#### **BID ADDENDUM #7**

Nanuet Union Free School District 103 Church Street Nanuet, NY 10954

Nanuet Bond Projects Phase 4

Date: May 1st, 2024

CODE COMPLIANCE

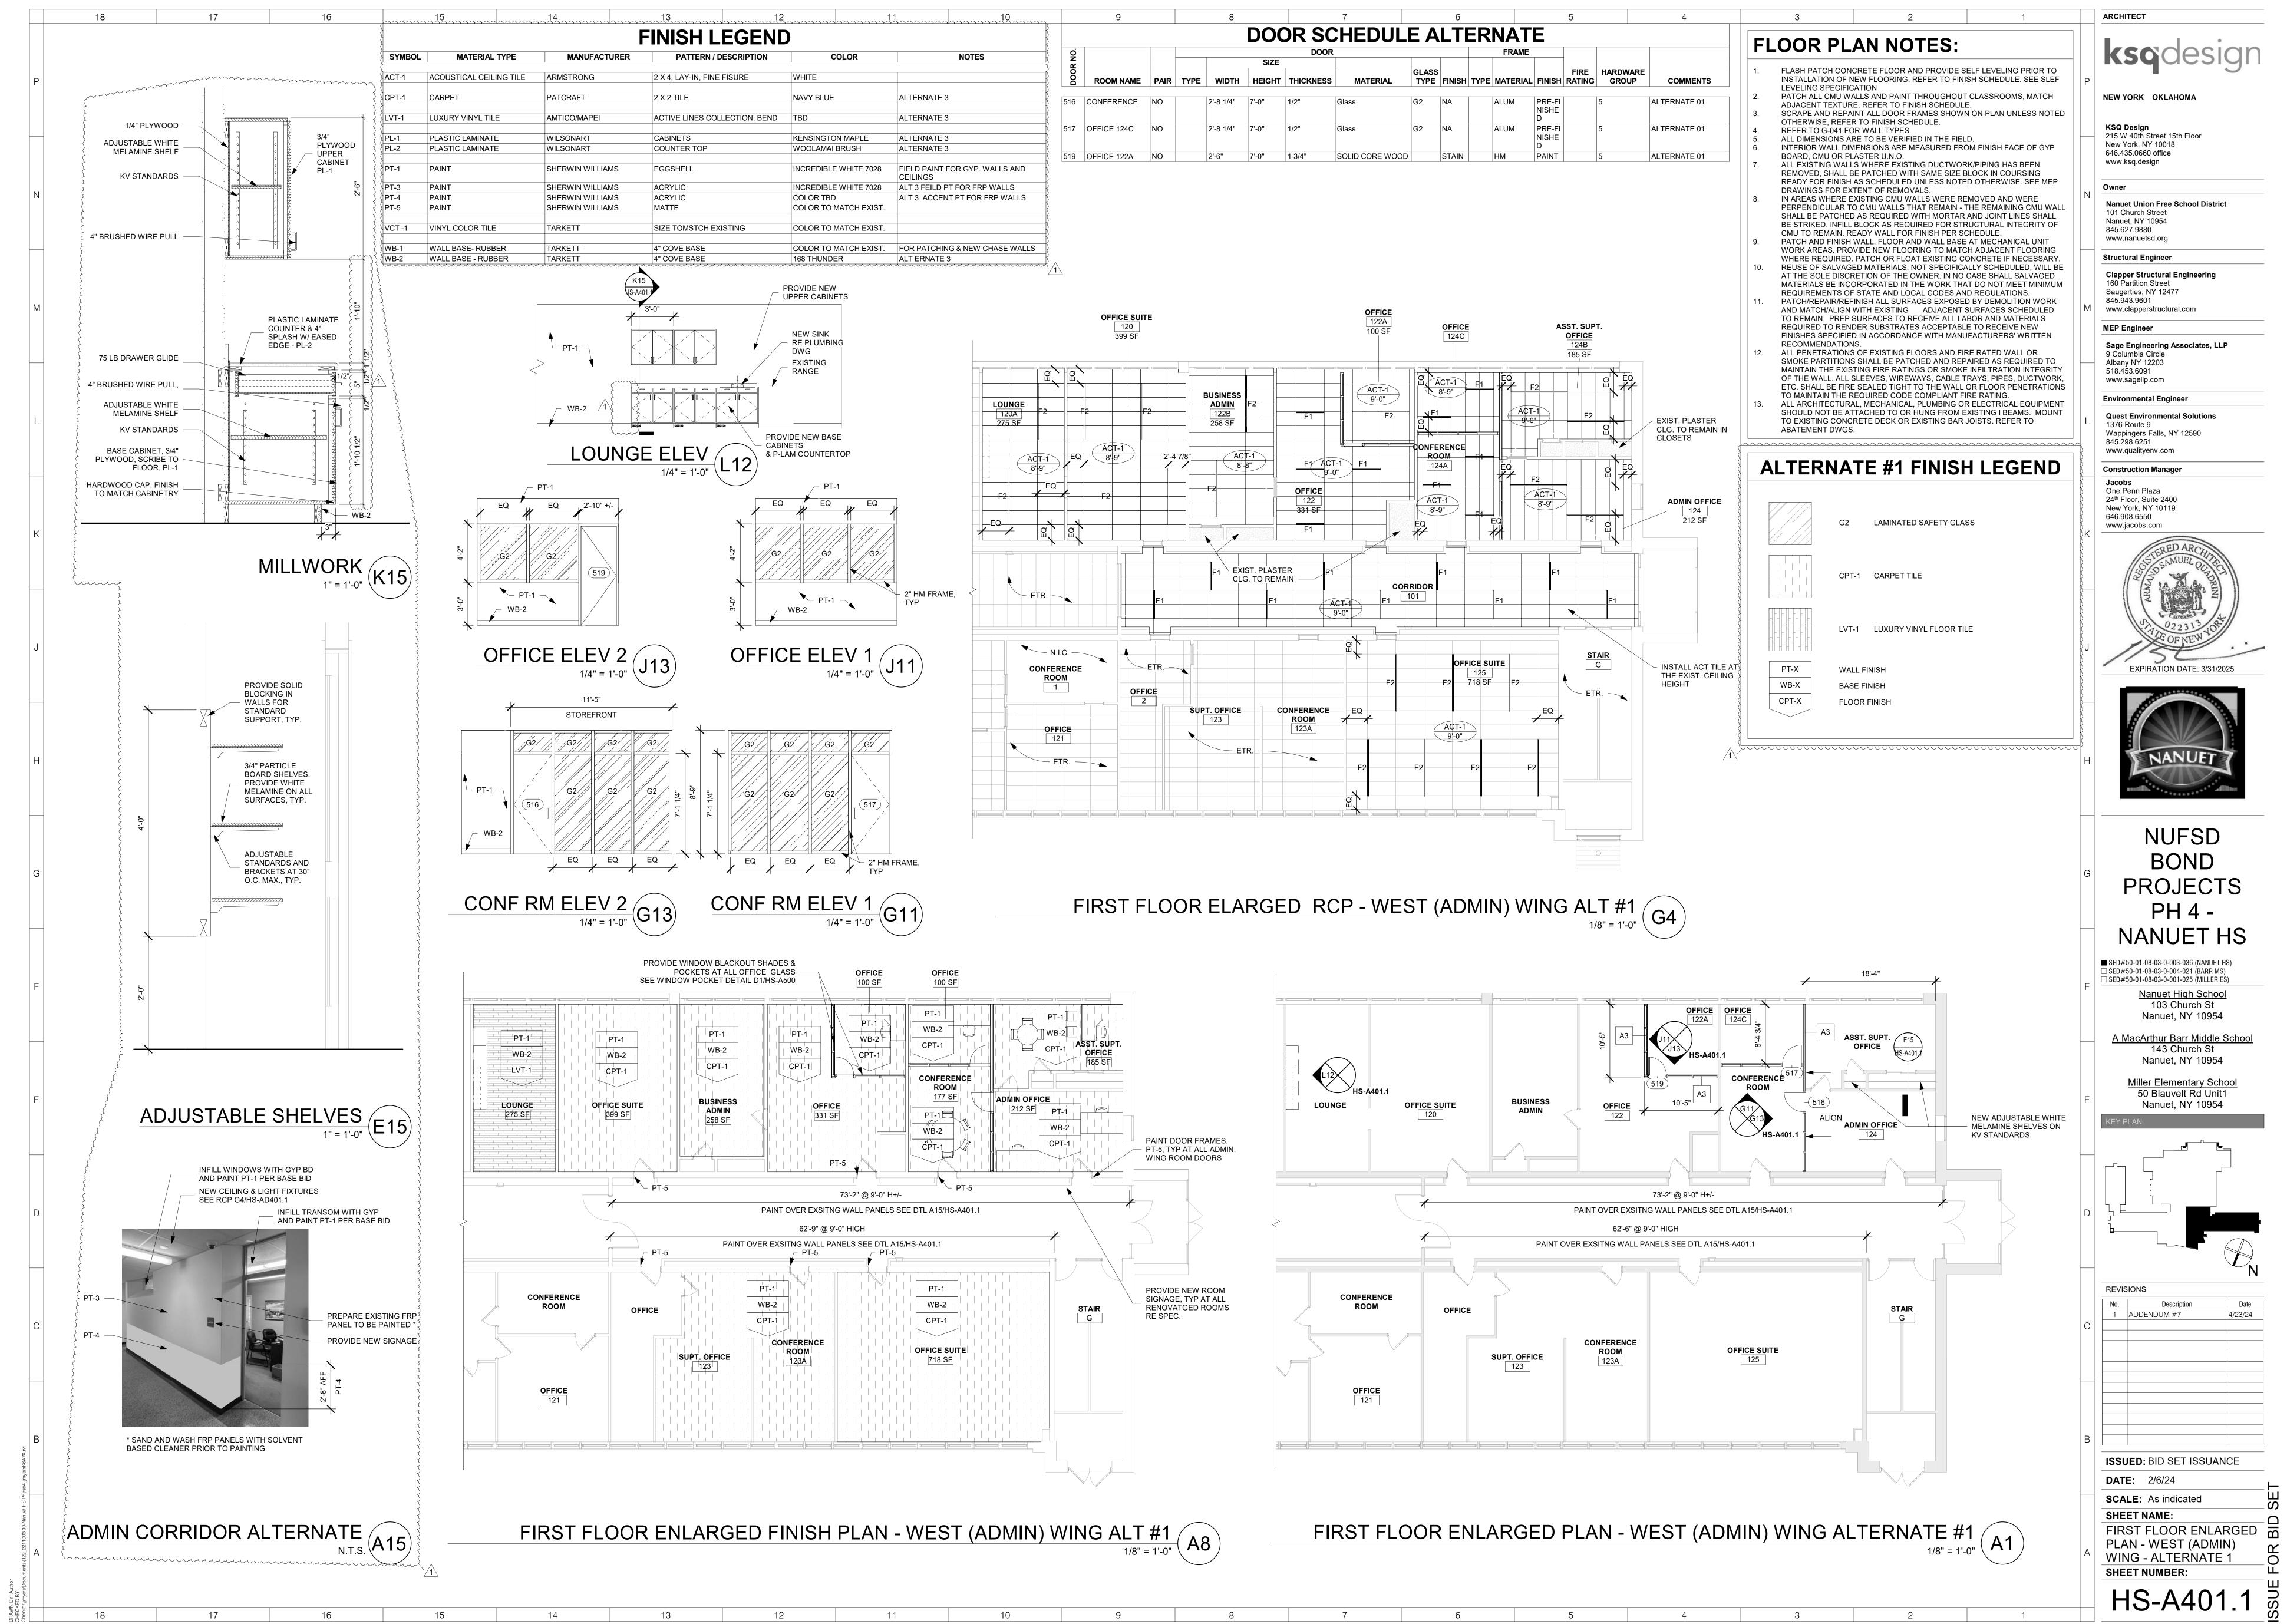
- 2. Sheet HS-A401.1: FIRST FLOOR ENLARGED PLAN WEST (ADMIN) WING ALT 1
  - A. ADA accessible counter height provided, revised finish legend, addition of details A15, E15, and K15.
- 3. Sheet BM-G021: CODE COMPLIANCE
  - A. Revised occupant load and plumbing fixture calculations on sheet.
- 4. Sheet BM-A401: ENLARGED 1ST & 2ND FLOOR RESTROOMS
  - A. Added ADA accessible electric door opener push plate at door.

SHEET NAME: ELECTRICAL SYMBOLS, LEGENDS AND **ABBREVIATIONS**

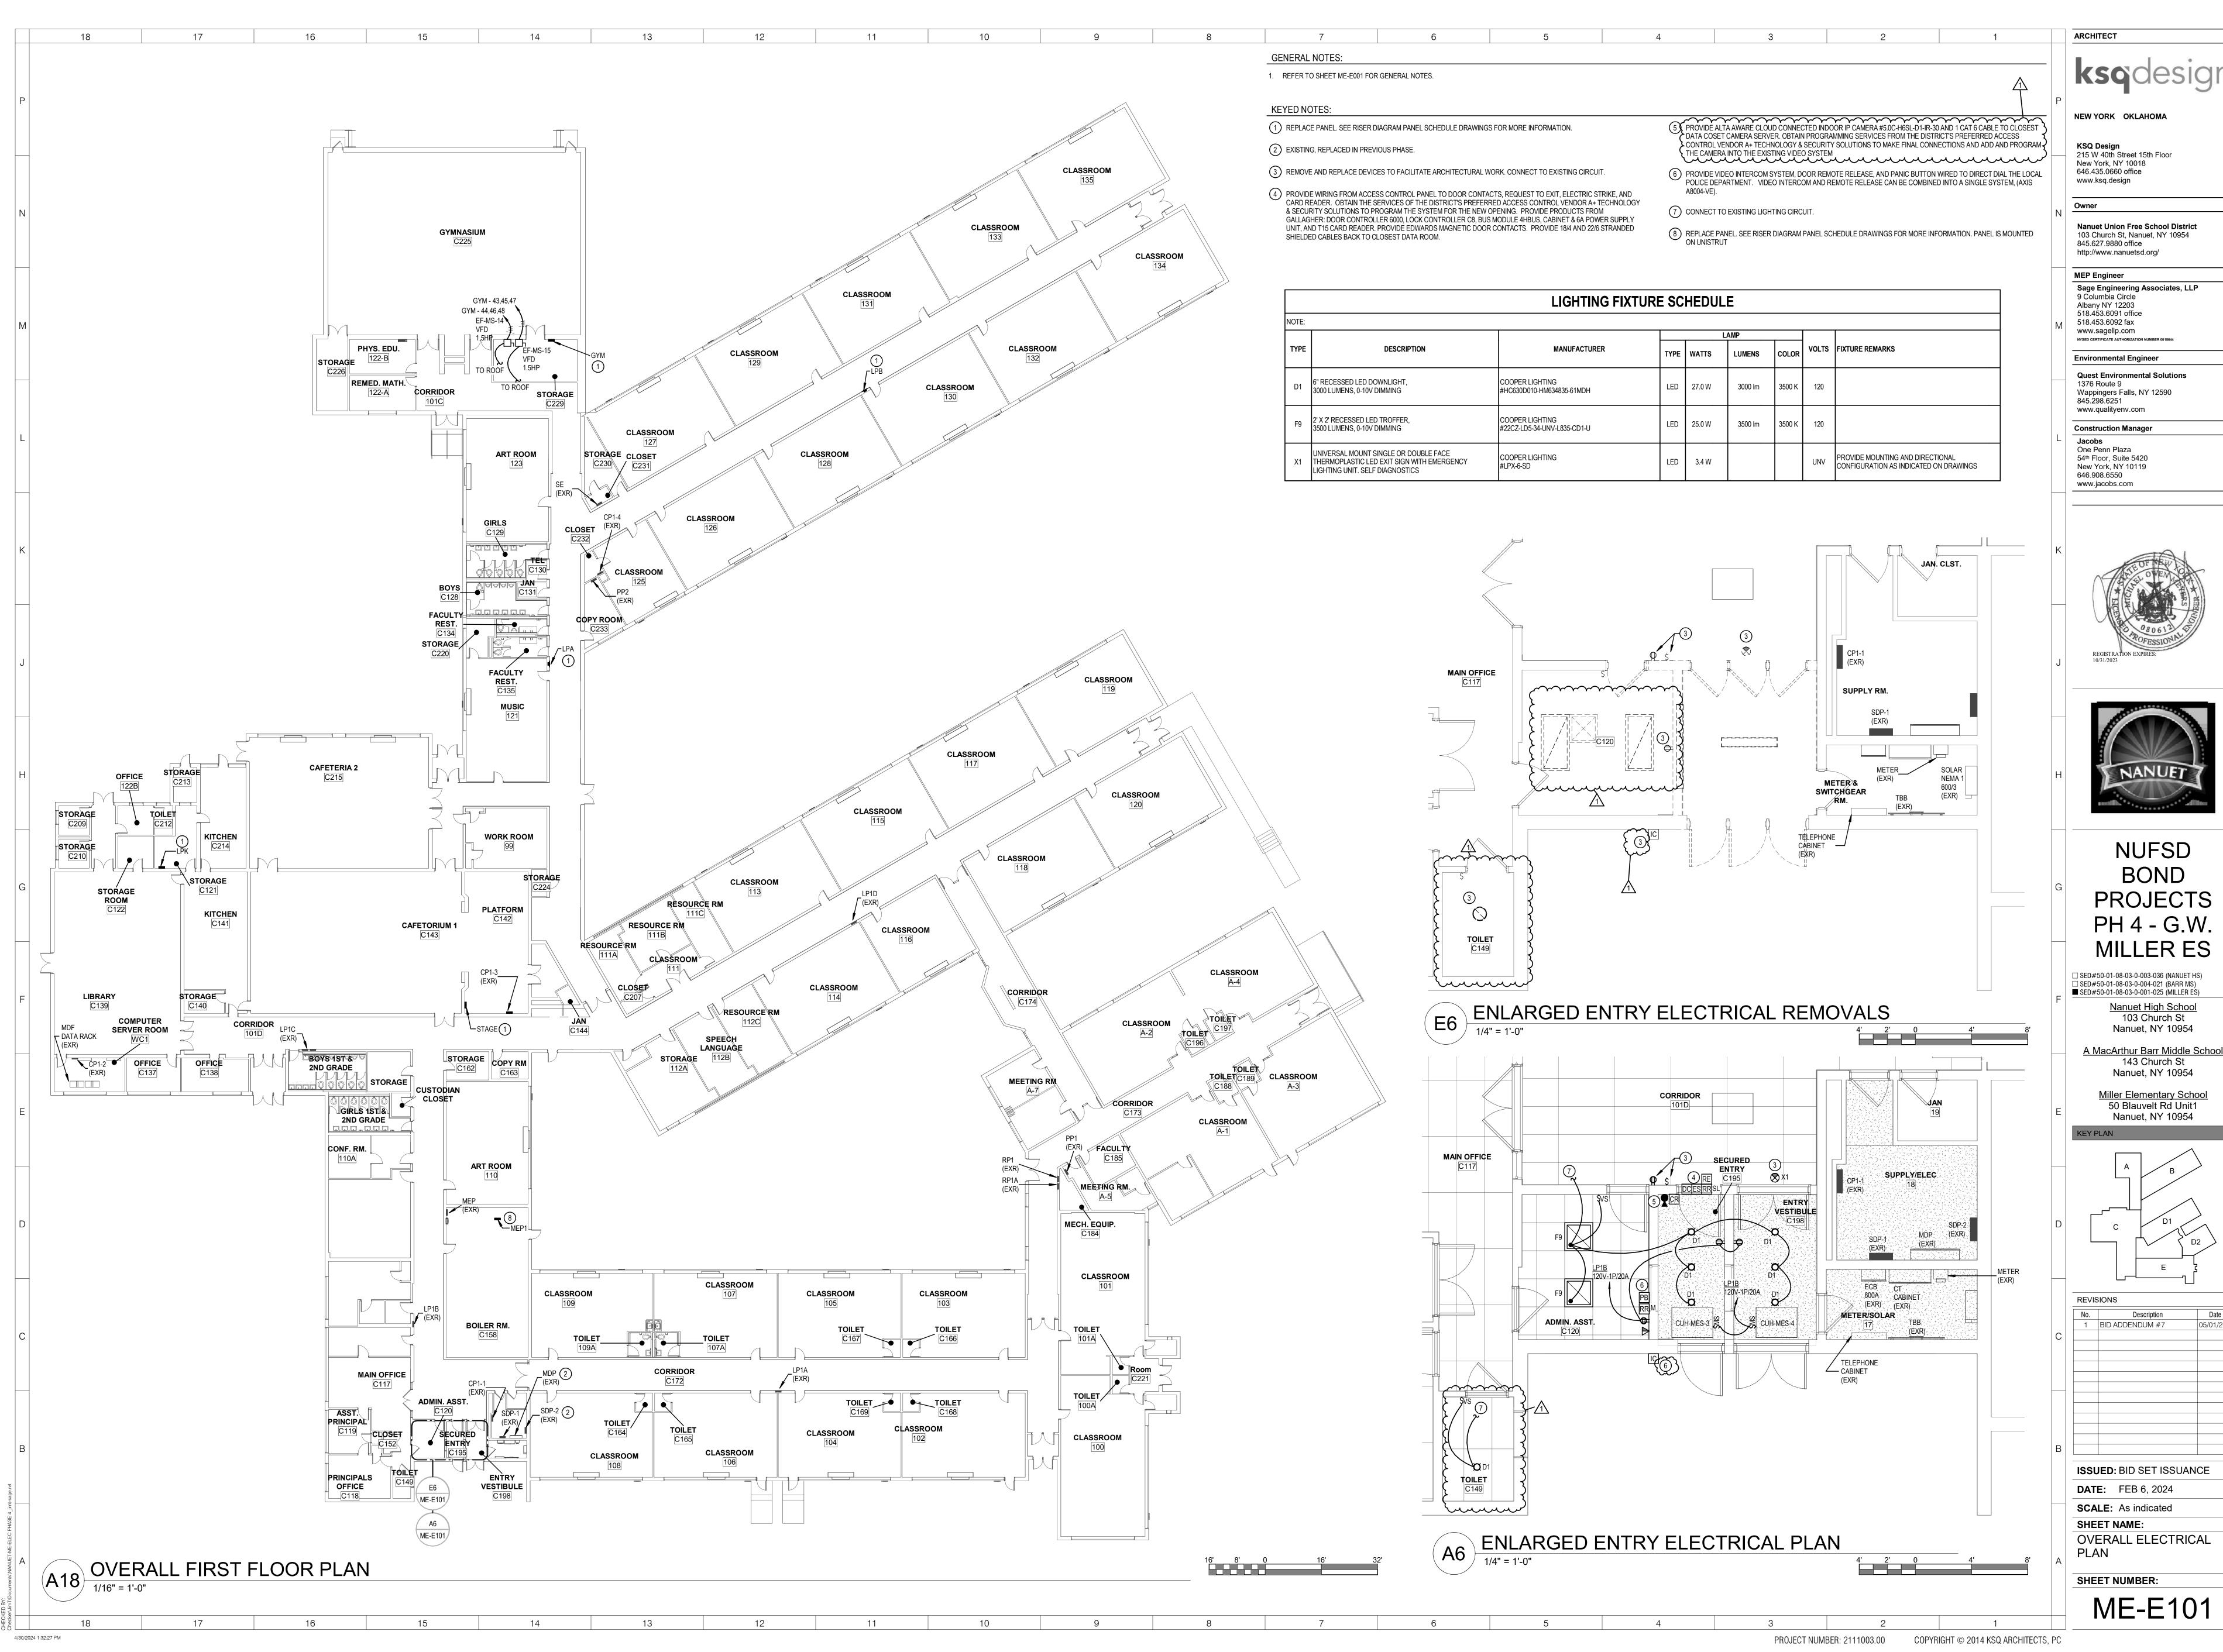
- 1. Sheet BM-E001: ELECTRICAL SYMBOLS, LEGENDS AND ABBREVIATIONS
  - A. Added detail A7
- 2. Sheet BM-E101: FIRST FLOOR ELECTRICAL PLANS
  - A. Added door operator and push plate. Updated light fixture schedule and electrical plans.

SHEET NAME: DETAILS AND DIAGRAMS

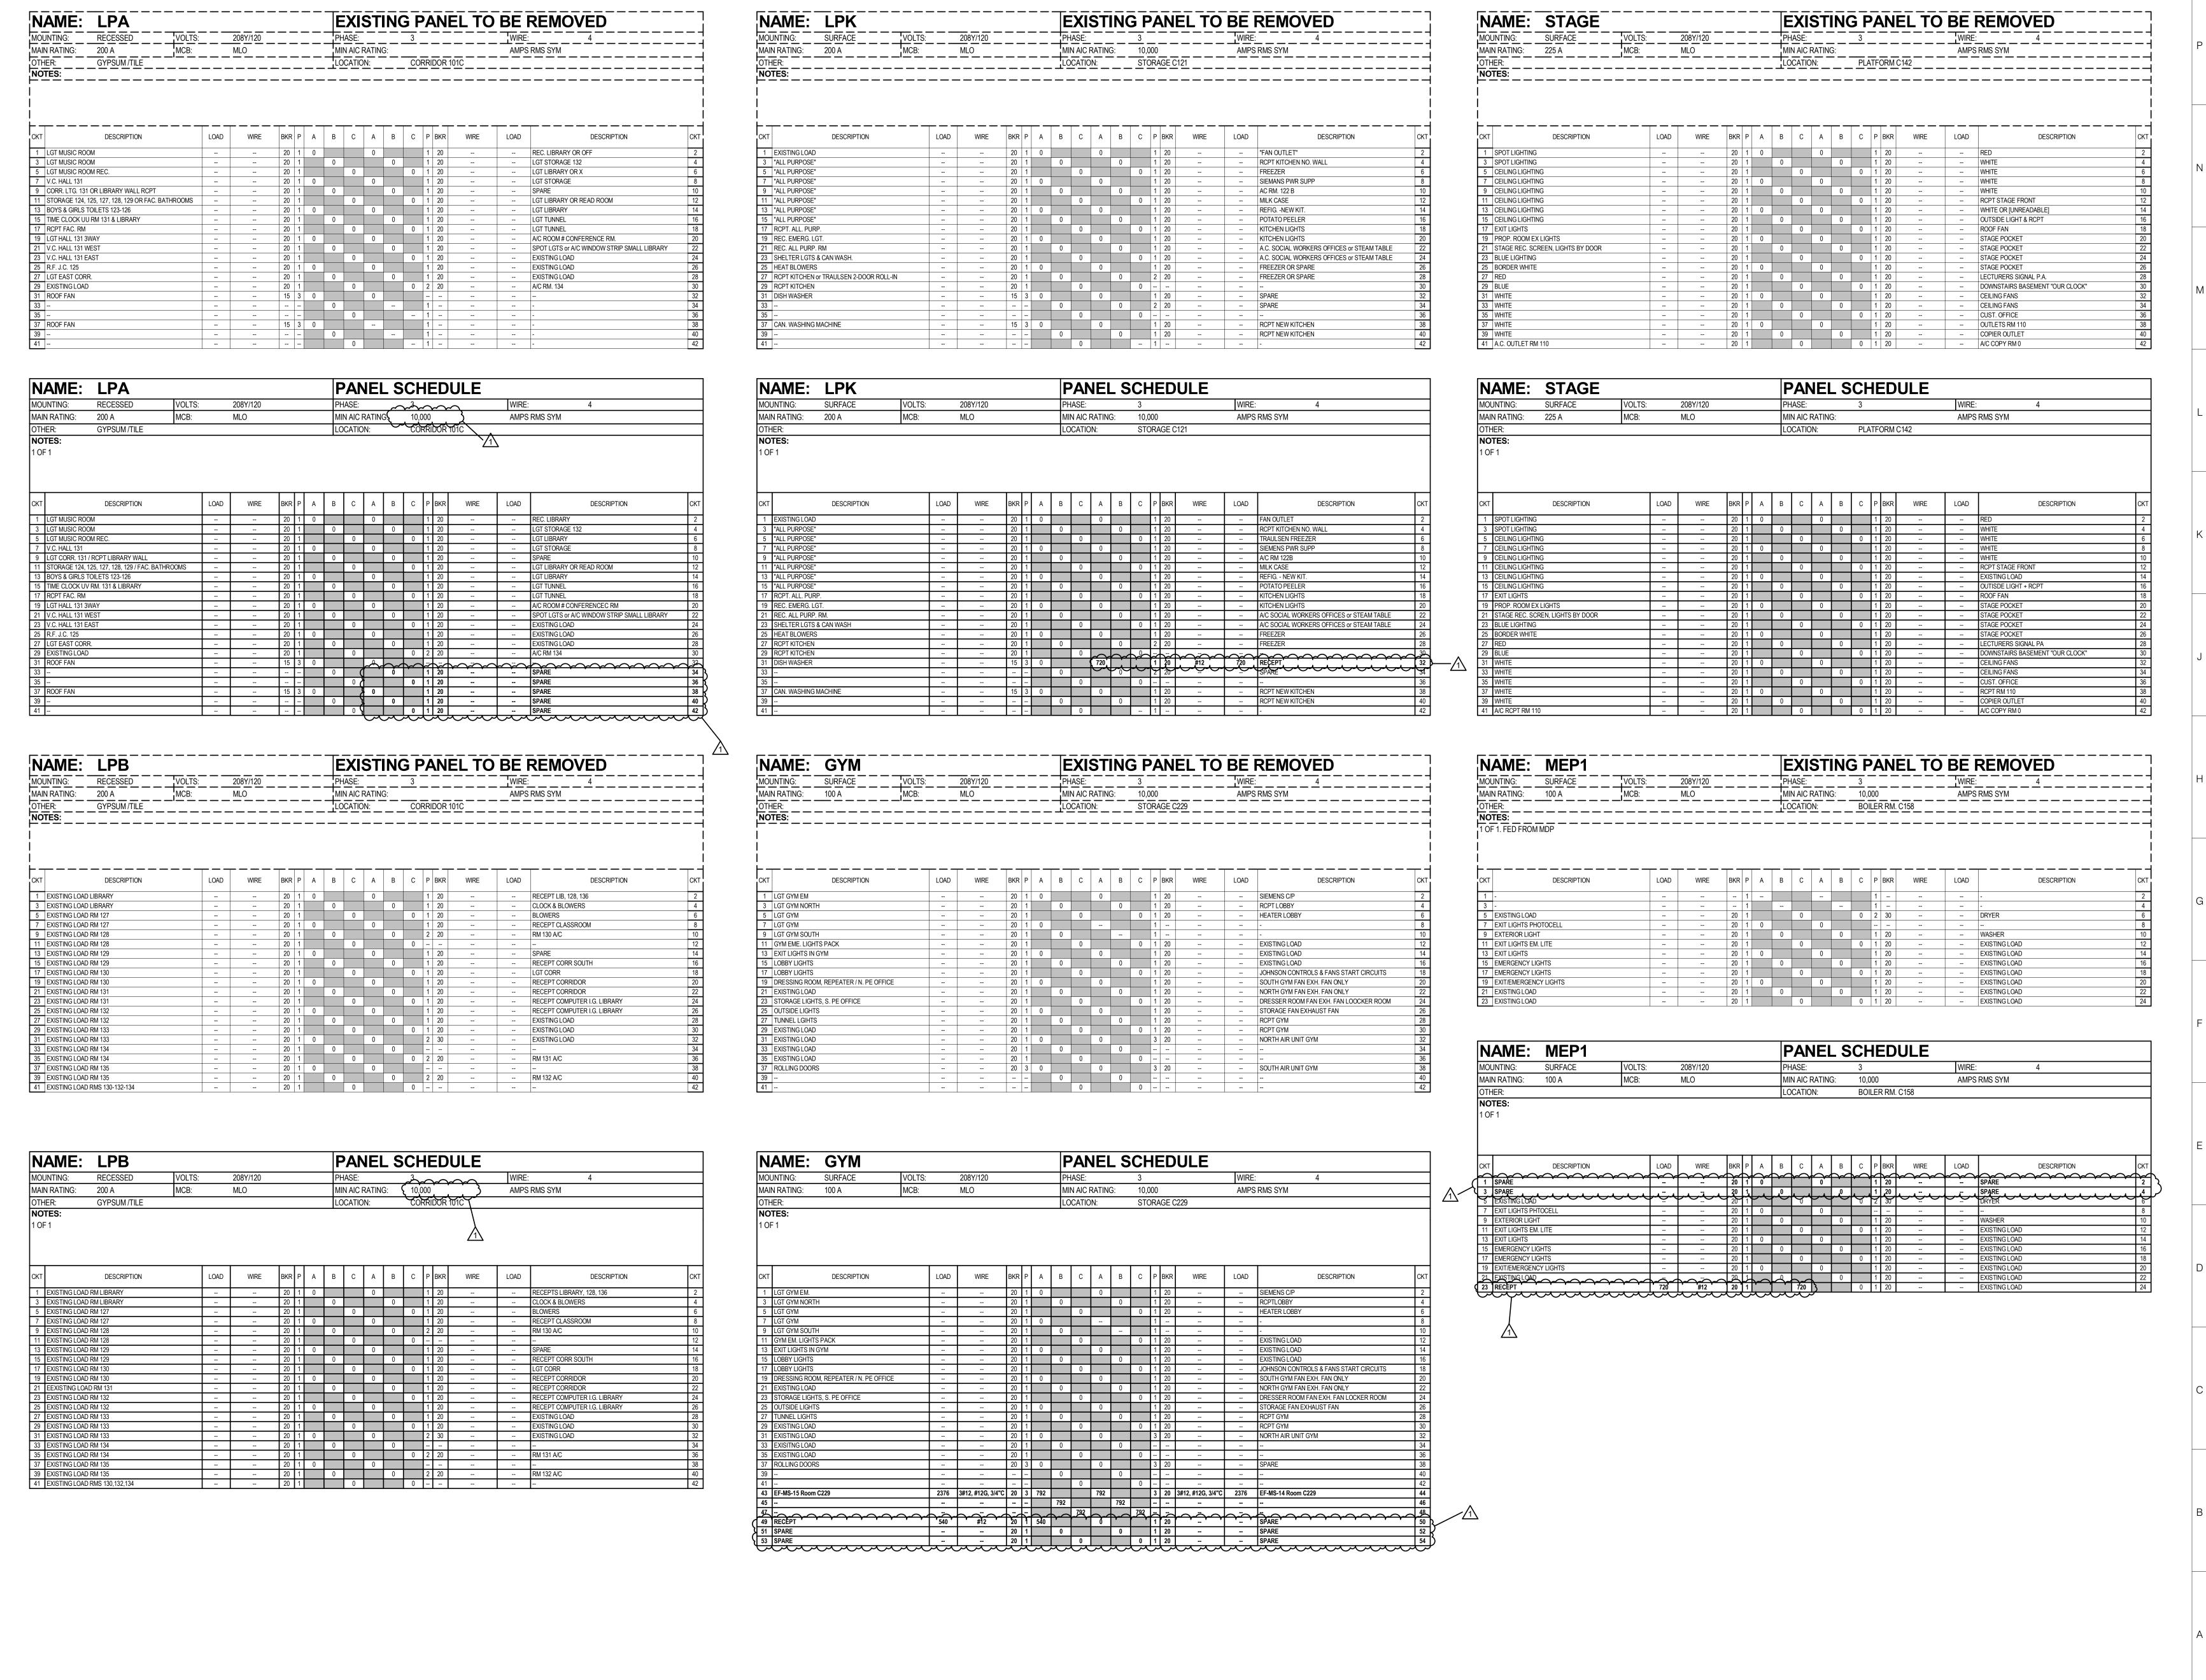
- A. Updated "Single Line Diagram Existing"
- 12. Sheet ME-E601: PANEL SCHEDULES
  - A. Updated panel schedules as noted.
